HANFORD FEDERAL FACILITY AGREEMENT AND CONSENT ORDER

1992 ANNUAL UPDATE

AMENDMENT 3

CHANGE FORM M-17-91-05

FIGURE D-1 WORK SCHEDULE

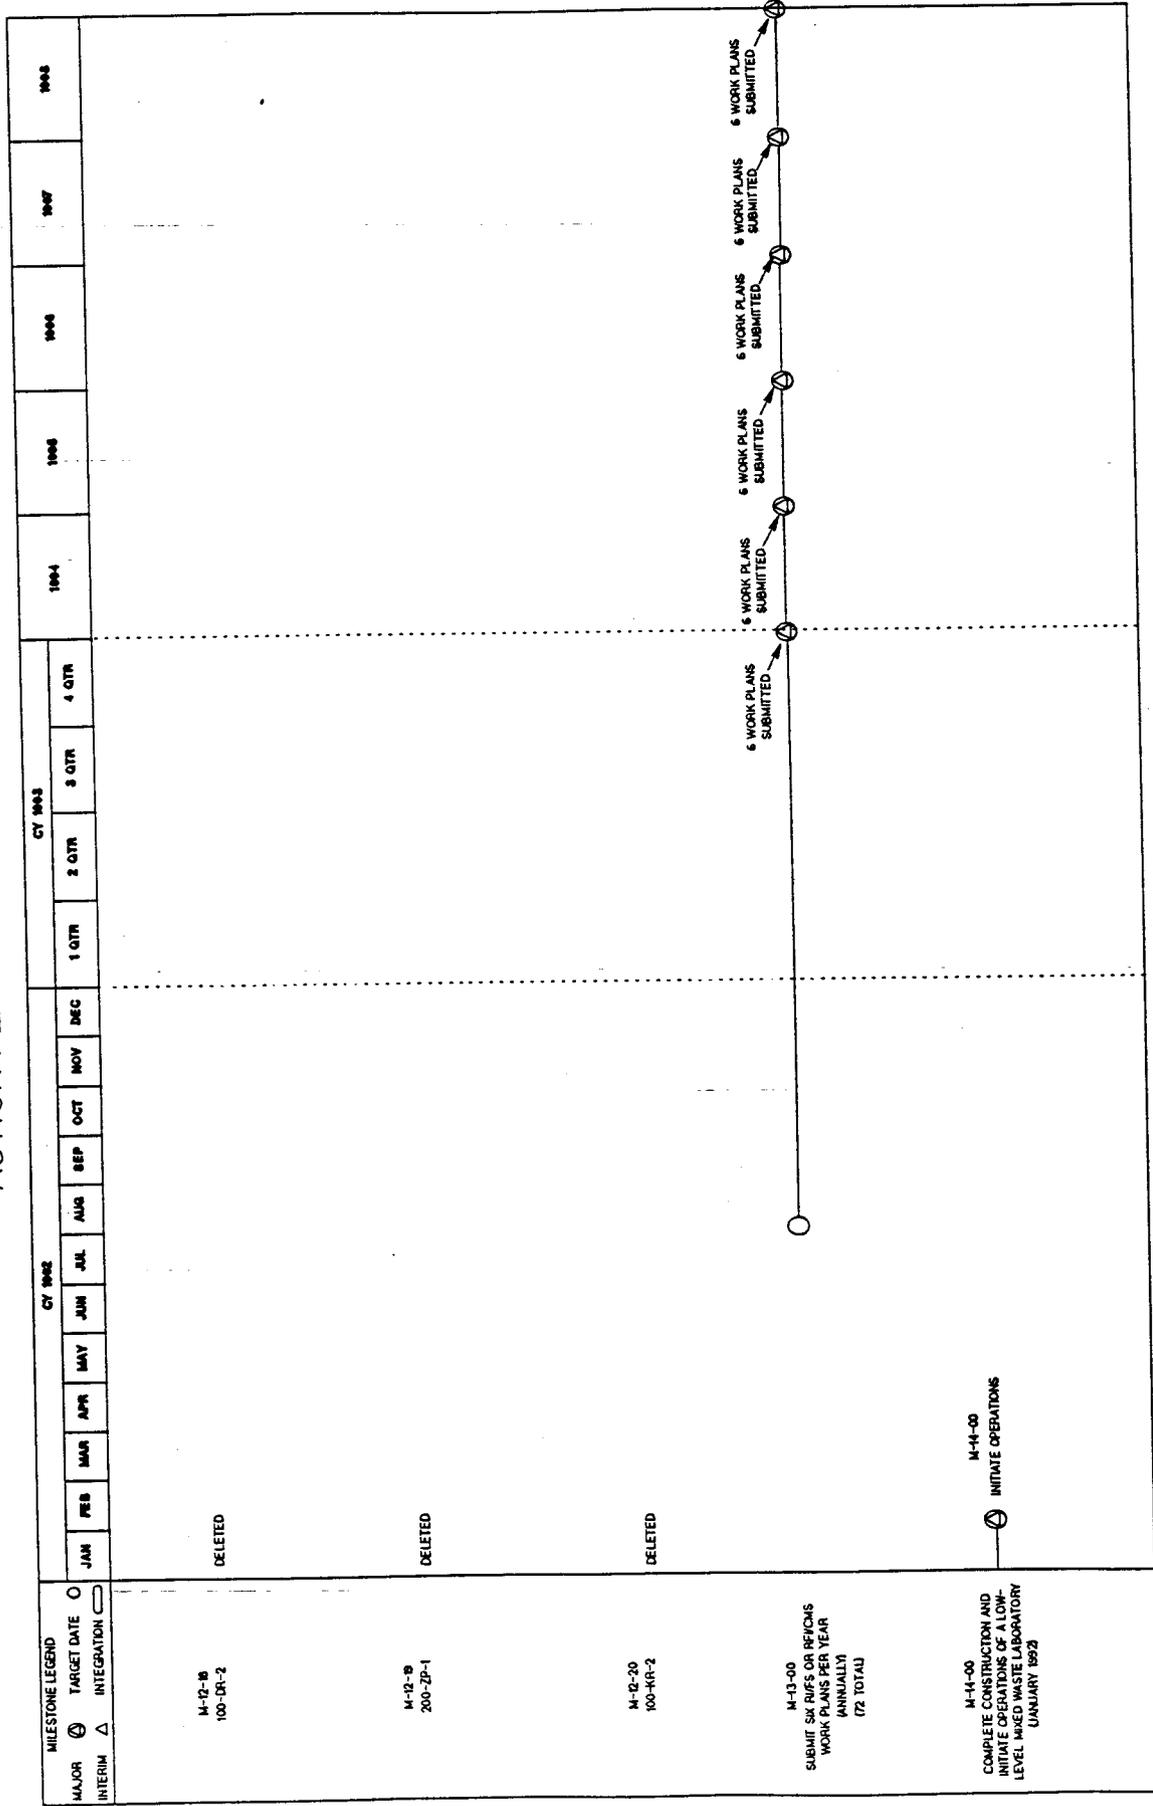
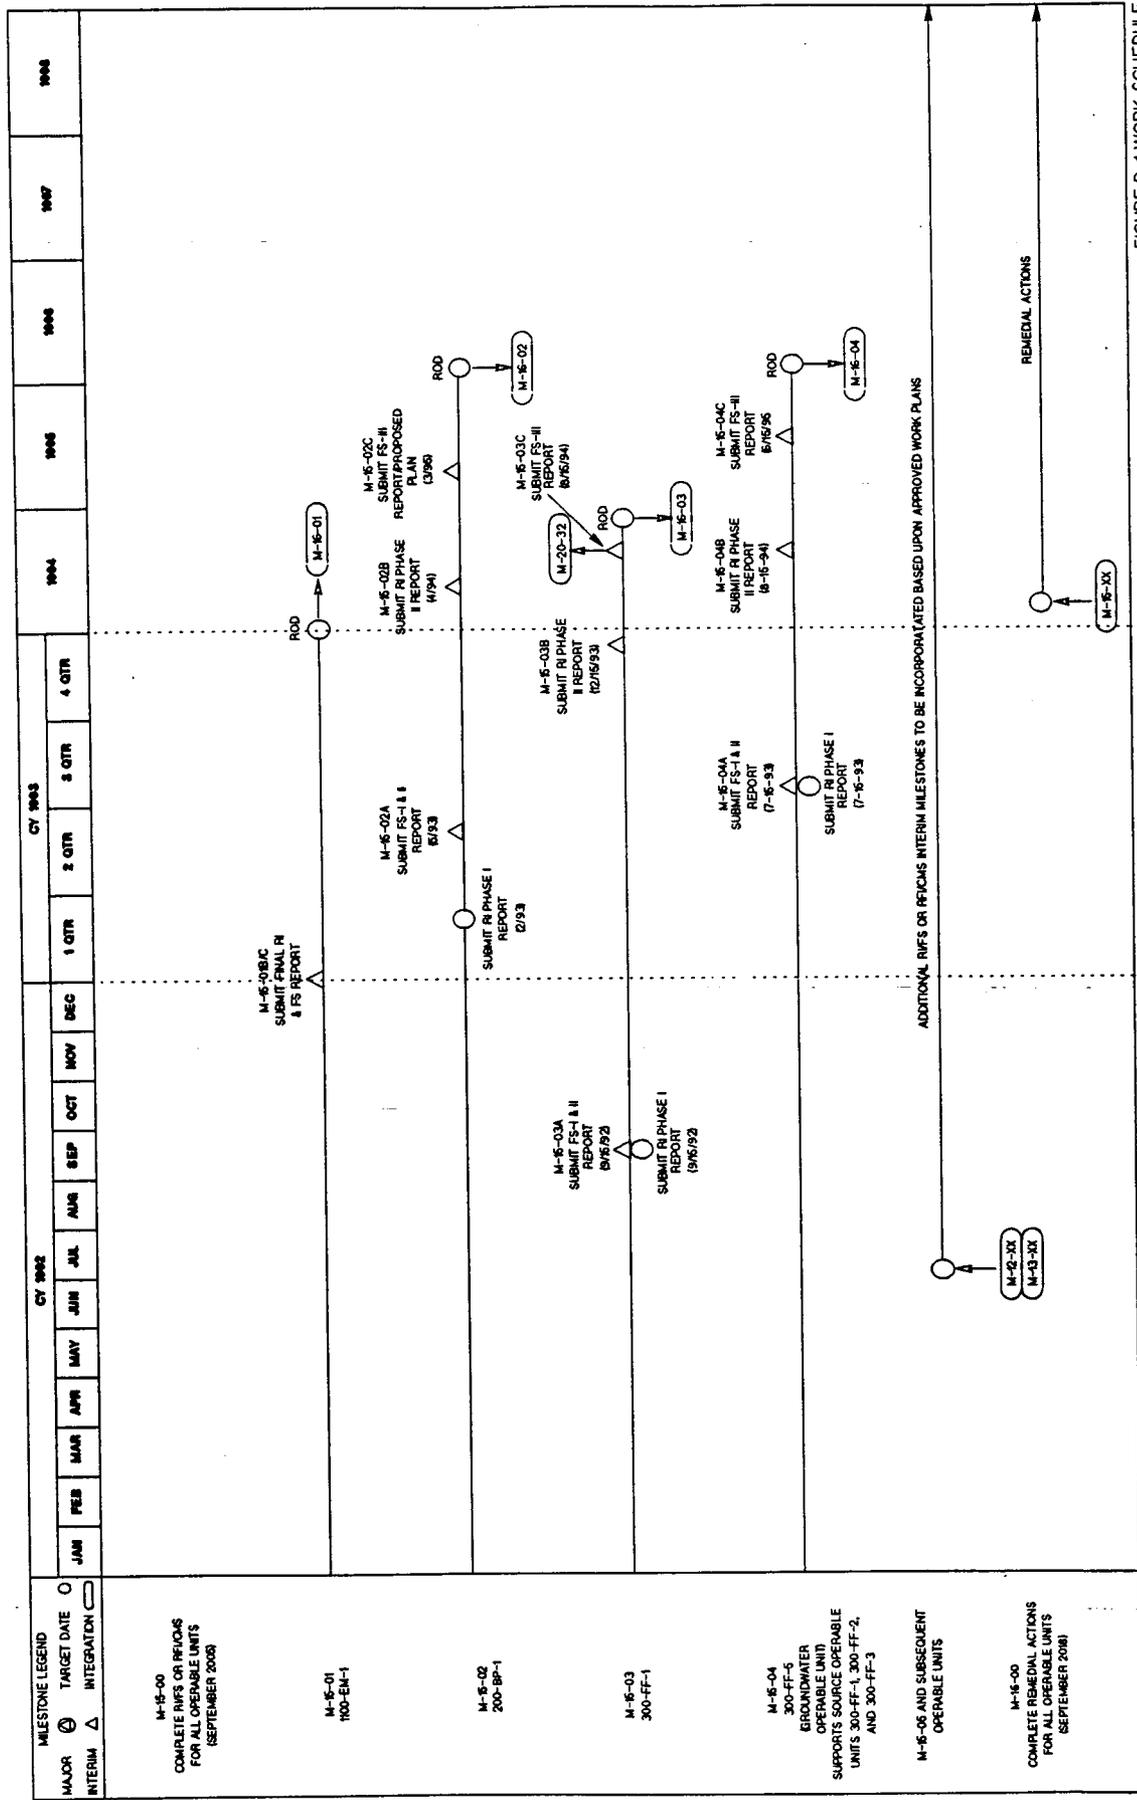
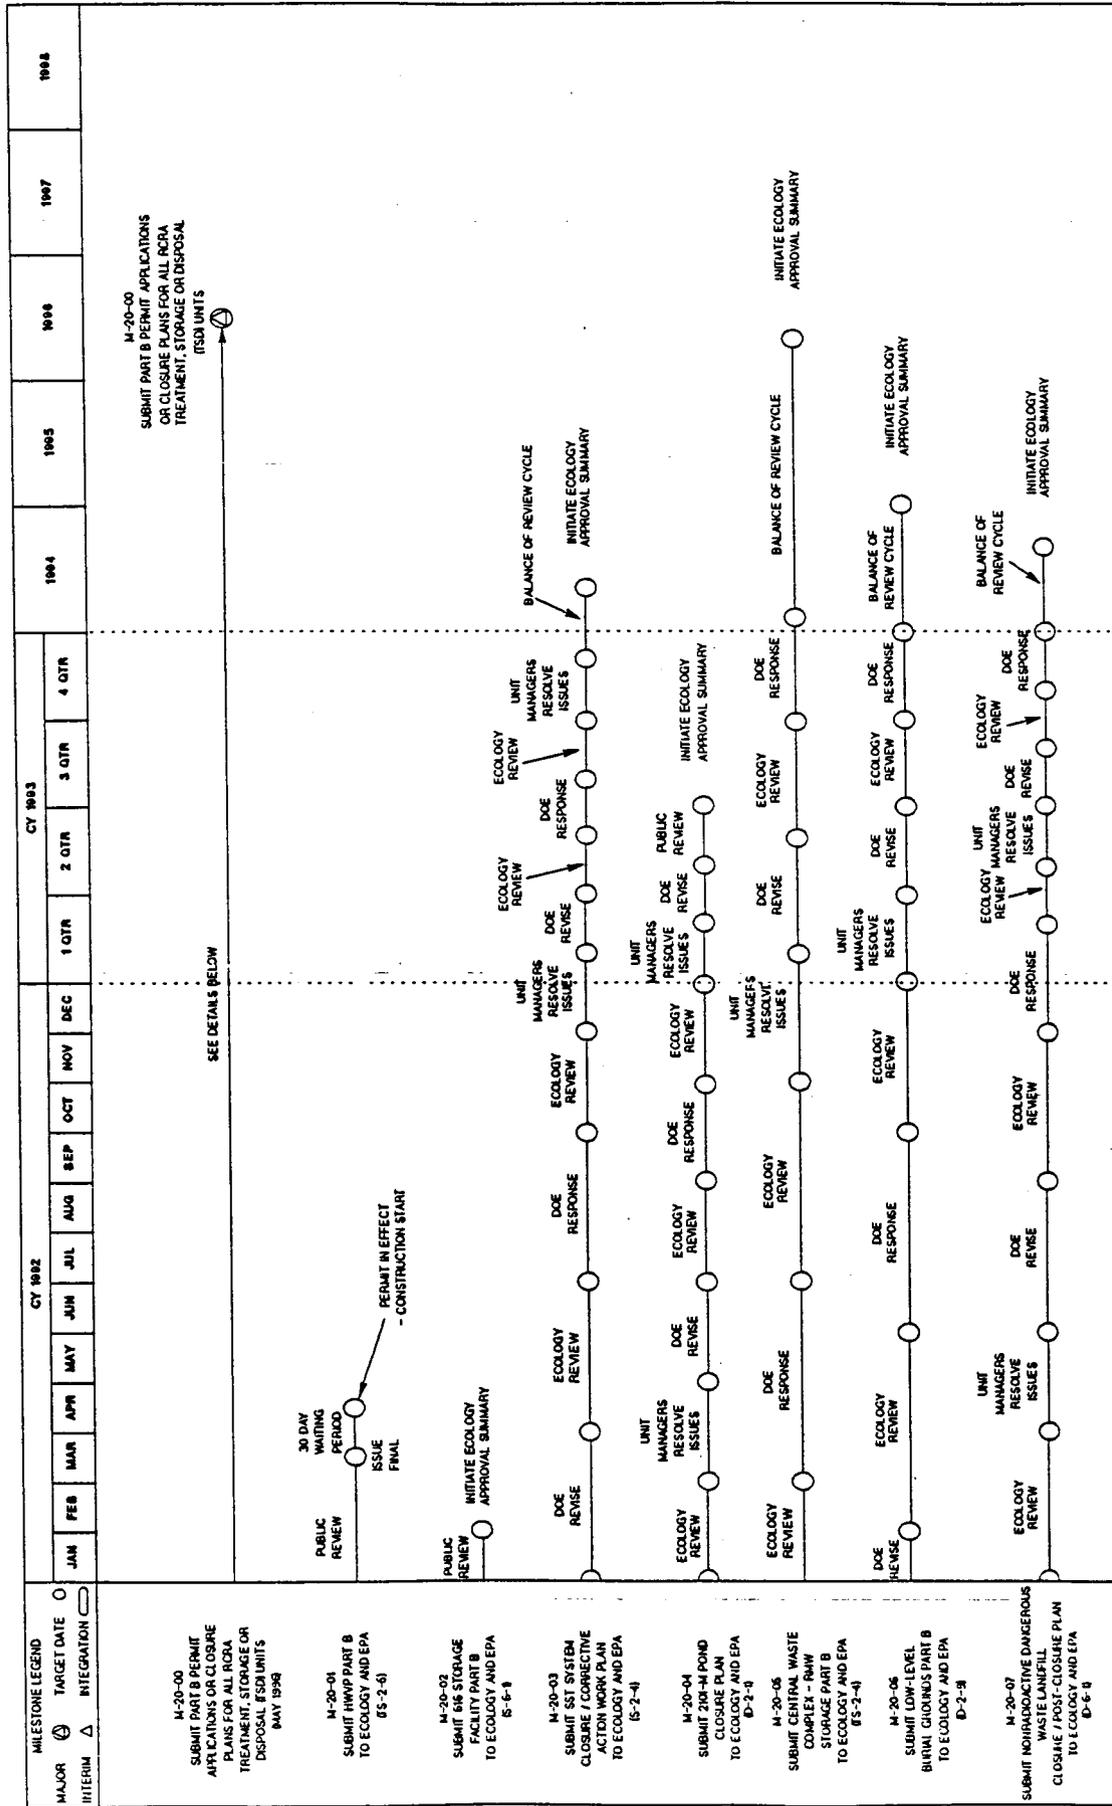
This annual update has revised the previous work schedule by deleting the previous two years (1990 and 1991), providing monthly activity detail for the current year (1992) and providing quarterly detail for the next year (1993). Two new calendar years (1997 and 1998) have been added to the end of the work schedule. The annual update has retained the same format as the original work schedule, with the incorporation of approved milestone changes in accordance with Section 12 of the Agreement Action Plan.

Figure 9-2. Part B Permit Application and Closure/Postclosure Plan Process Flowchart.

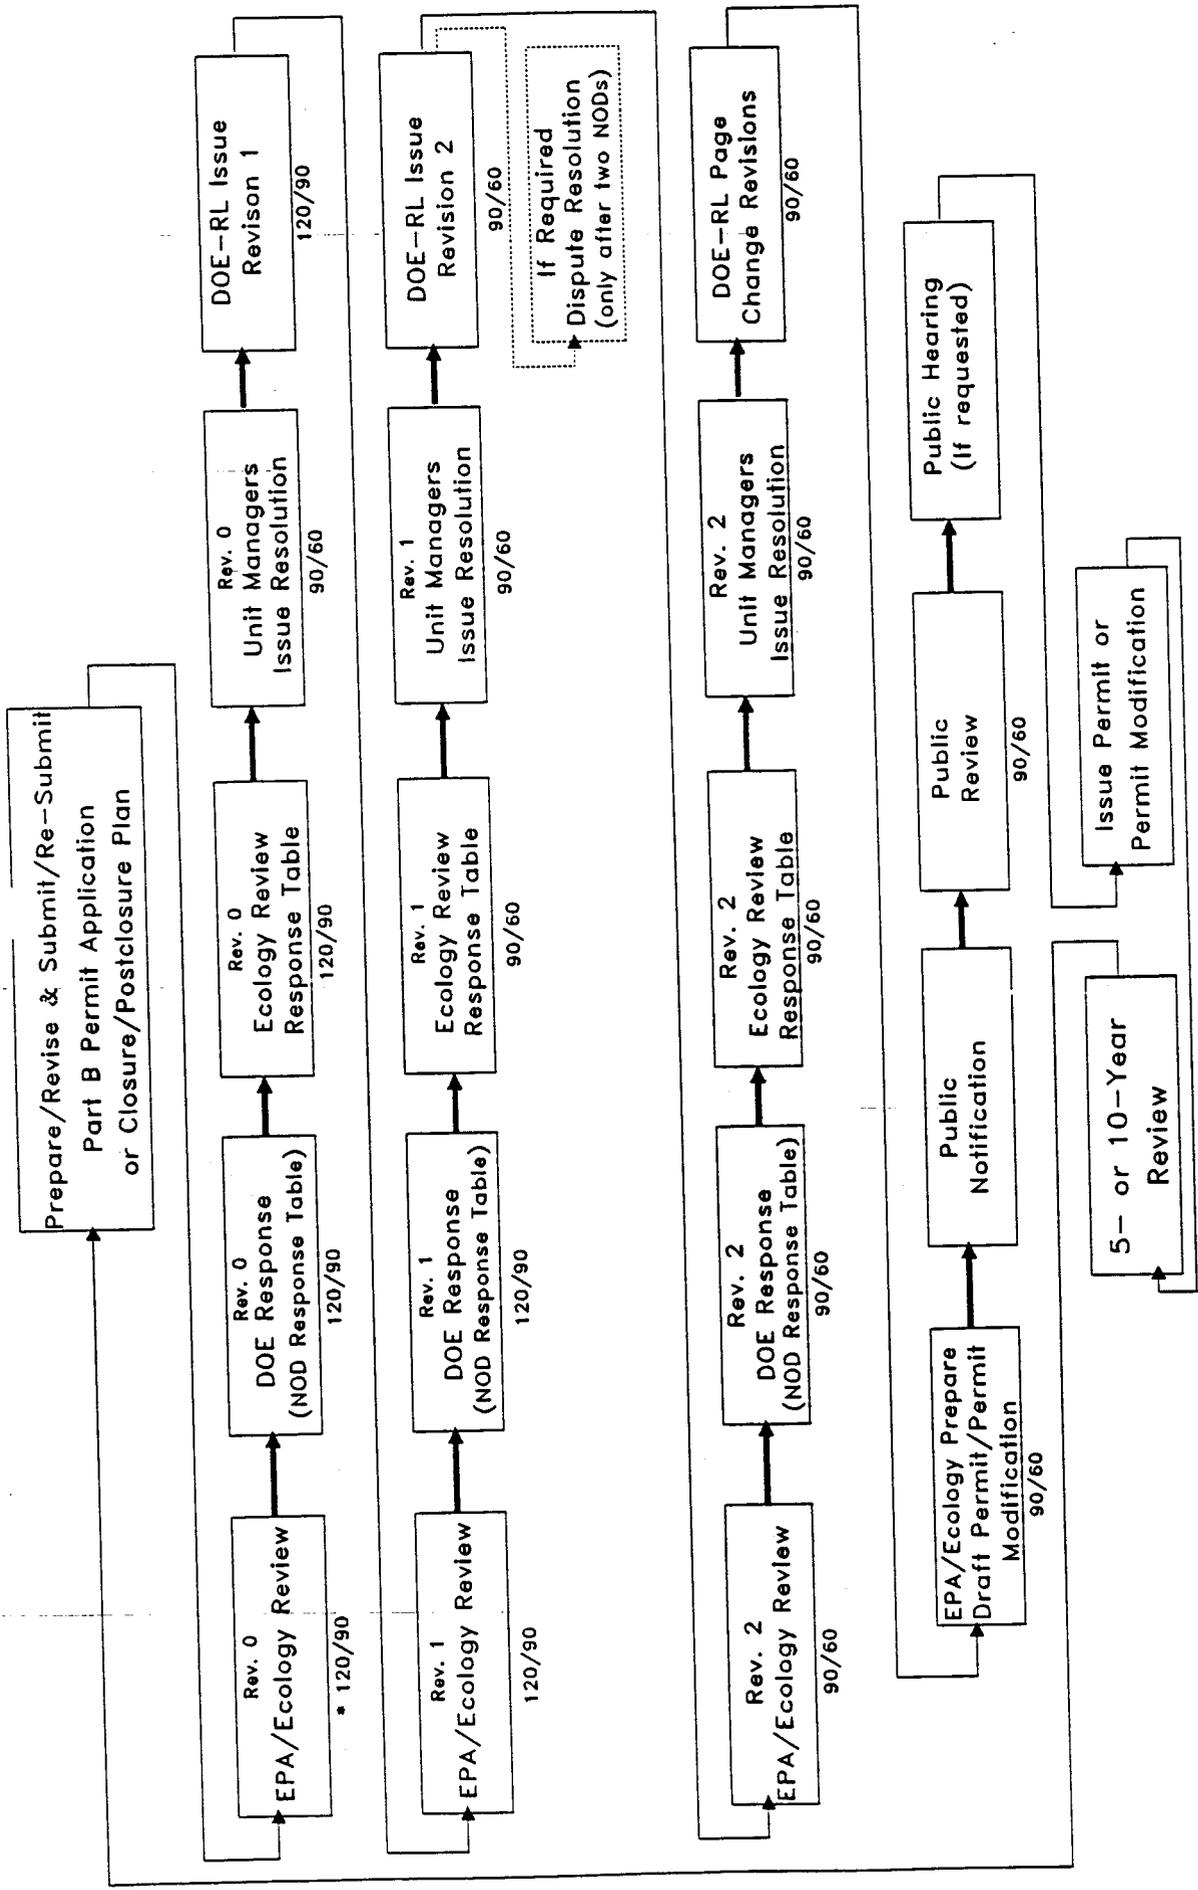
Item Number	Location	Change
5.	Figure 9-2	response summary and incorporated in accordance with 173-303-840(7) and (9) WAC. Public hearing opportunities are further discussed in Section 10.7.
		Delete current Figure 9-2 and replace with new Figure 9-2 as displayed on next page of this amendment.
